CERTIFICATE OF APPROPRIATENESS

Property: 504 Avondale St, lot 2, tract 3A, block 6, Montrose Subdivision. The property includes a historic 3,124 square foot two-story residence situated and detached garage on a 7,800 square foot (60' x 130') interior lot.

Proposal: Alteration – Replace all wood 1-over-1 windows with wood 1-over-1 windows to fit within existing openings. An application to replace all wood 1-over-1 windows with vinyl 1-over-1 windows was denied at the October 23, 2014 meeting.

Recommendation: **Denial – does not satisfy criteria 1, 4, 5, 9**

WINDOWS – PAINTED SHUT, SOME ROT, LOOSE GLASS

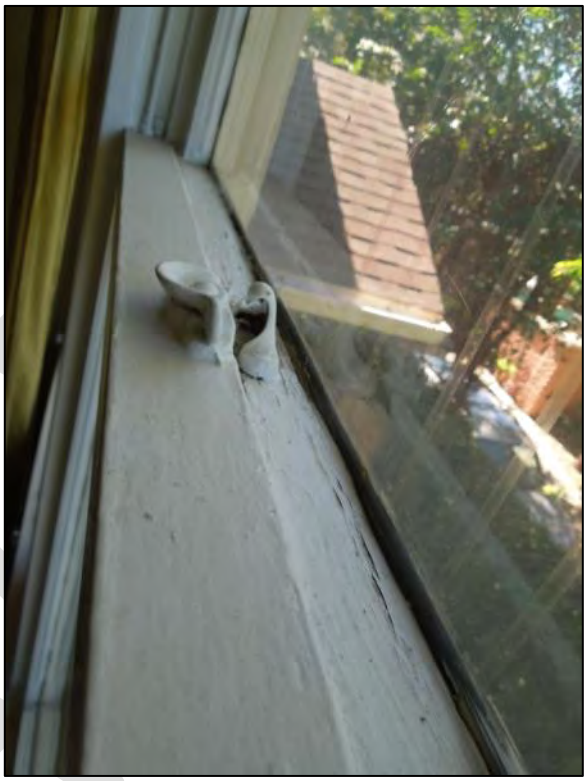
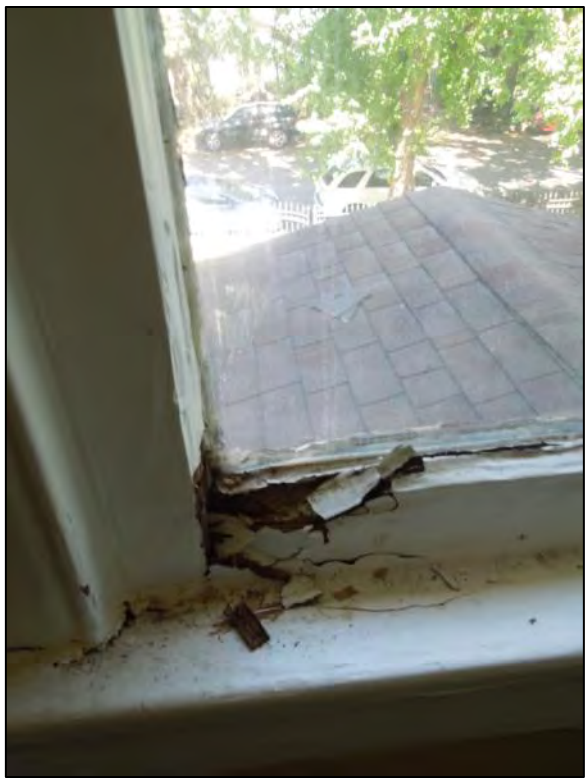
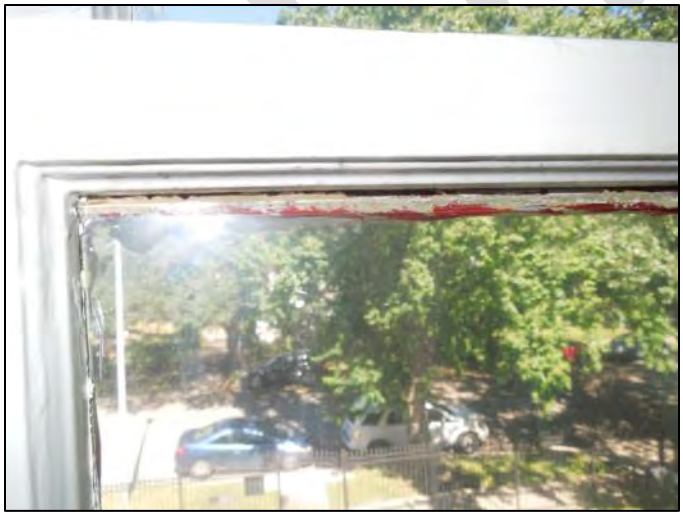
S	D	NA		
☐	☒	☐	(1)	The proposed activity must retain and preserve the historical character of the property; *The original wood windows are a distinguishing feature of the property and should be retained. Staff confirmed some damage of the original windows but believe they are not beyond reasonable repair.*
☒	☐	☐	(2)	The proposed activity must contribute to the continued availability of the property for a contemporary use;
☒	☐	☐	(3)	The proposed activity must recognize the building, structure, object or site as a product of its own time and avoid alterations that seek to create an earlier or later appearance;
☐	☒	☐	(4)	The proposed activity must preserve the distinguishing qualities or character of the building, structure, object or site and its environment; *The original wood windows are a distinguishing feature of the property and should be retained. Staff confirmed some damage of the original windows but believe they are not beyond reasonable repair.*

☐	☒	☐	(5)	The proposed activity must maintain or replicate distinctive stylistic exterior features or examples of skilled craftsmanship that characterize the building, structure, object or site; *The original wood windows are a distinguishing feature of the property and should be retained. Staff confirmed some damage of the original windows but believe they are not beyond reasonable repair.*
☒	☐	☐	(6)	New materials to be used for any exterior feature excluding what is visible from public alleys must be visually compatible with, but not necessarily the same as, the materials being replaced in form, design, texture, dimension and scale;
☒	☐	☐	(7)	The proposed replacement of missing exterior features, if any, should be based on an accurate duplication of features, substantiated by available historical, physical or pictorial evidence, where that evidence is available, rather than on conjectural designs or the availability of different architectural elements from other structures;
